LINCOLN CITY/LANCASTER COUNTY PLANNING STAFF REPORT

PROJECT #: Special Permit No. 16025

PROPOSAL: A request per Section 27.63.320 for a Community Unit Plan to develop up to 7 dwelling units.

LOCATION: 828 D Street and 848 D Street

G1.1

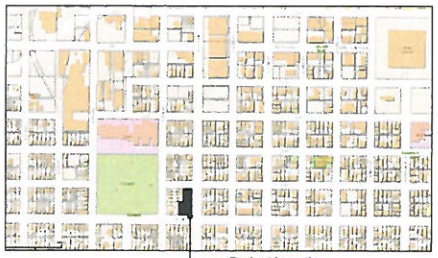
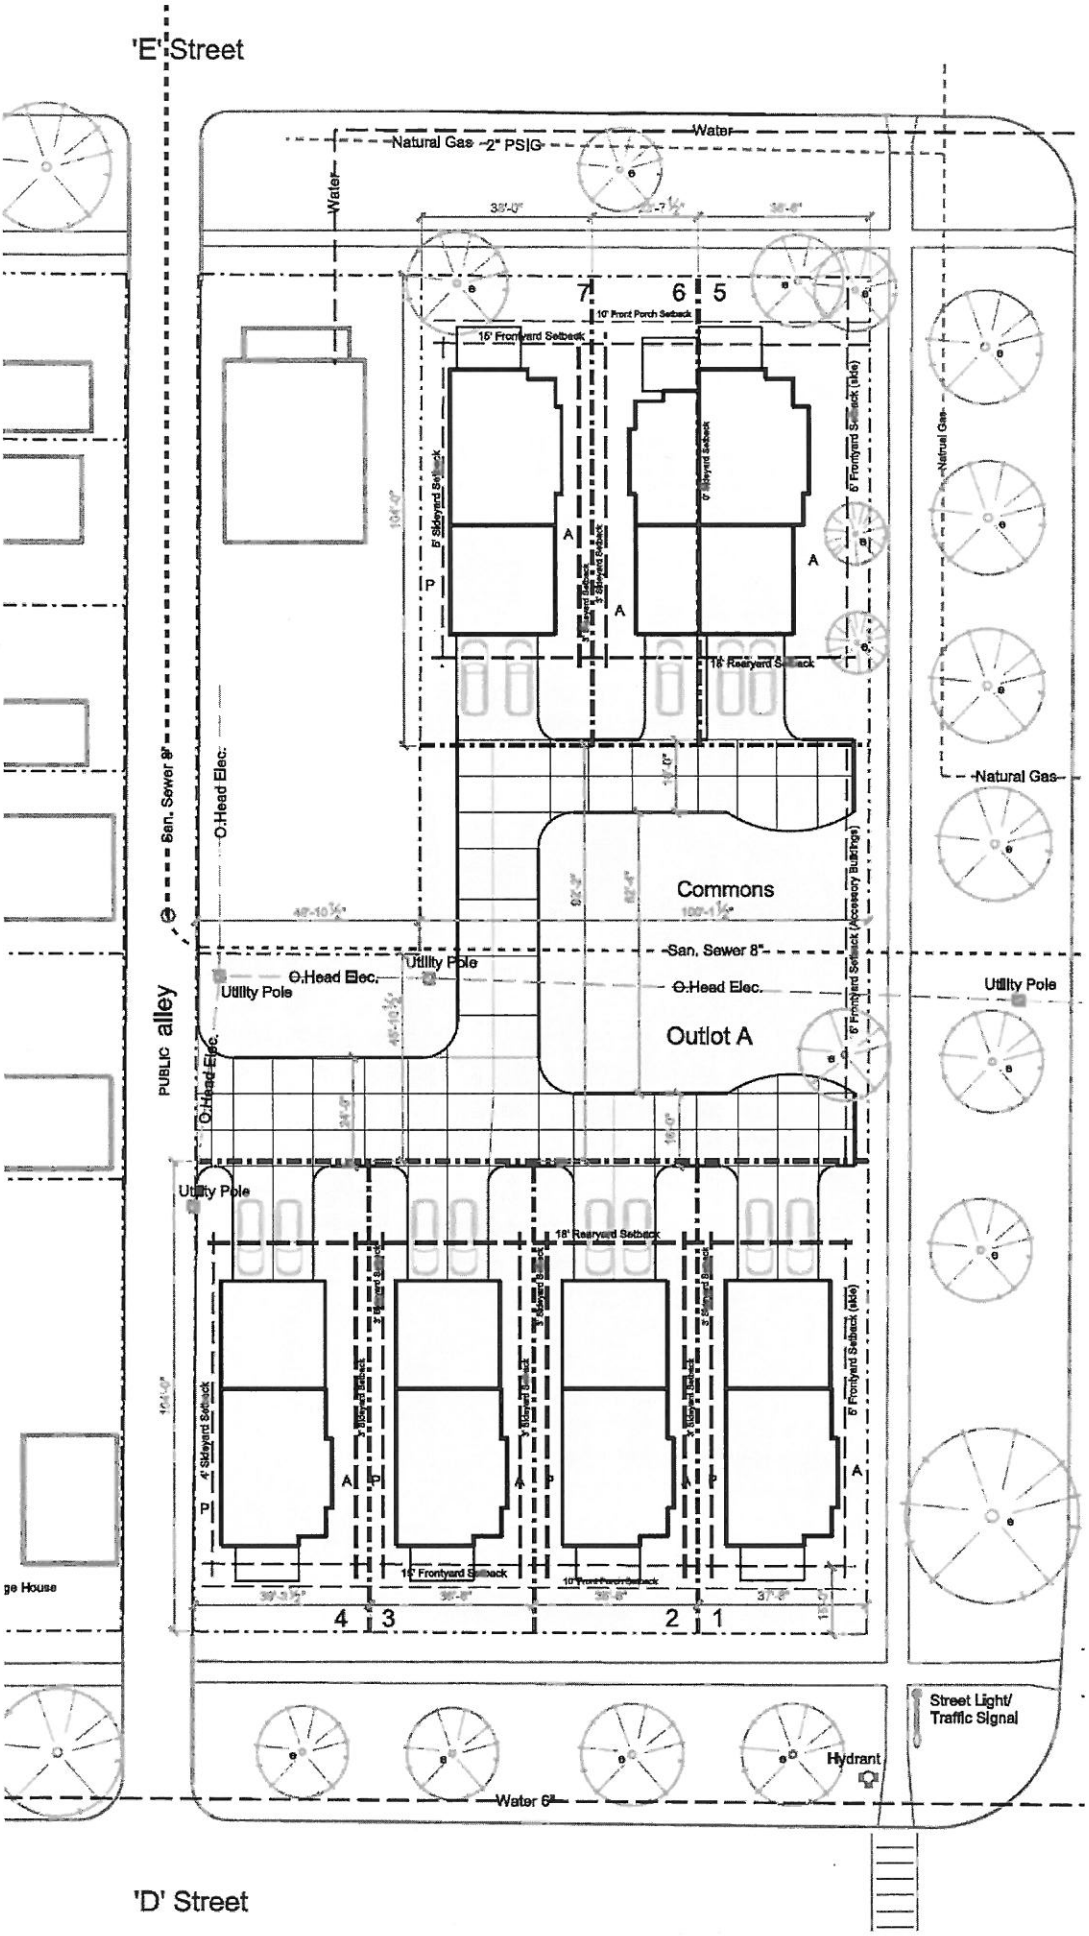
1.1 Revise the sheet numbering to show “Sheet 1 of 1" for Sheet G1.1 as this will be the only sheet for the approved CUP.

1.2 Revise the sheet title to read, “Cooper Commons Community Unit Plan, Special Permit #16025" and delete the “Submittal Documents” subtitle.

1.3 Under the Proposed CUP table, correct “Font” to “Front”.

1.4 Remove the “Drawing Index”.

1.5 Remove “(side)” from the front yard setback label along 9th Street.

1.6 Revise Note A.3 to state “Building footprints are conceptual and may be located anywhere within the approved building envelopes.”

1.7 Revise Note B.2 to state “Accessory Buildings are permitted in the identified Commons area in Outlot A and must meet the minimum 5 foot front yard setback to 9th Street.”

1.8 Revise Note C.1 to state “A final plat will be required according to the proposed lot sizes.”

1.9 Revise Note C.2 to state “Proposed exterior home designs are subject to review and recommendation by the Historic Preservation Commission and must meet the Design Standards for Neighborhoods.”

1.10 Remove the “Lot Total - 8" under the Proposed Lots table.

1.11 Under the Proposed CUP table, change the proposed “3,714 average square feet” to “3,500 single family/ 2,400 two-family lots” to allow for minor variation.
